Substantive response of the Local Highway Authority to a planning consultation received under The Development Management Order.

Planning Application Number: 25/01161/OUT

Application Address: Land West Of Shilton Road Earl Shilton Leicestershire

Description of Application: Outline planning permission for the erection of up to 120 dwellings (all matters reserved)

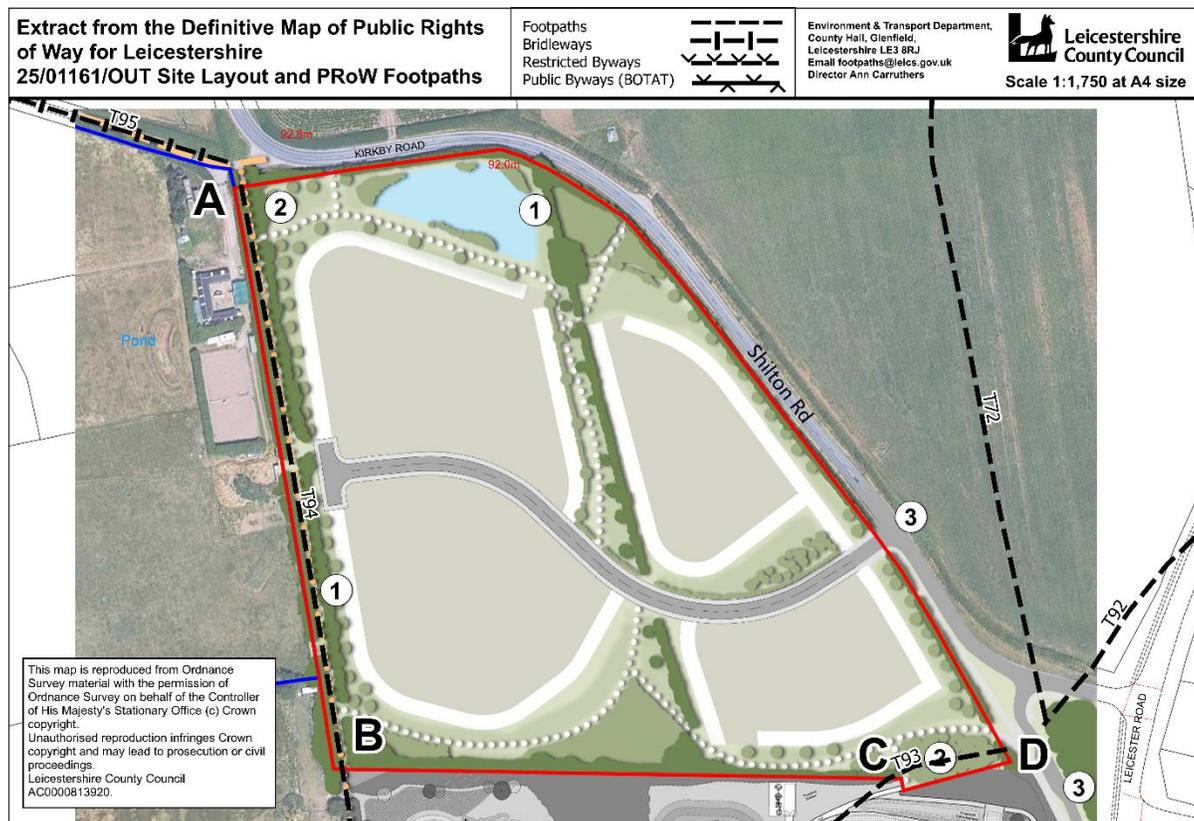
The application site includes two public rights of way as shown below on the Illustrative Site Layout overlaid with the Definitive Map of public rights of way, the official record. Footpath T94 runs inside the western site boundary between points labelled A and B. Footpath T93 runs through the southeastern corner of the site between points C and D; though the legal alignment here is further north that the current route between fences created sometime before 2018 so the fences may represent an unauthorised barrier on the legal alignment.

The LHA will require planning conditions including a treatment scheme for the PROW which will need to include measures such as management during construction (including proposed temporary route(s)); ensuring plans reflect the correct legally-recorded PROW alignments, or any legal processes to ensure they do so in future; and any new construction works.

The public footpath will need to be upgraded to meet design and construction standards set out in the LHDG. For these works to be adequately monitored and delivered in accordance with these criteria the works to the highway (the public footpath) will likely need to be included in a Section 38/278 Agreement.
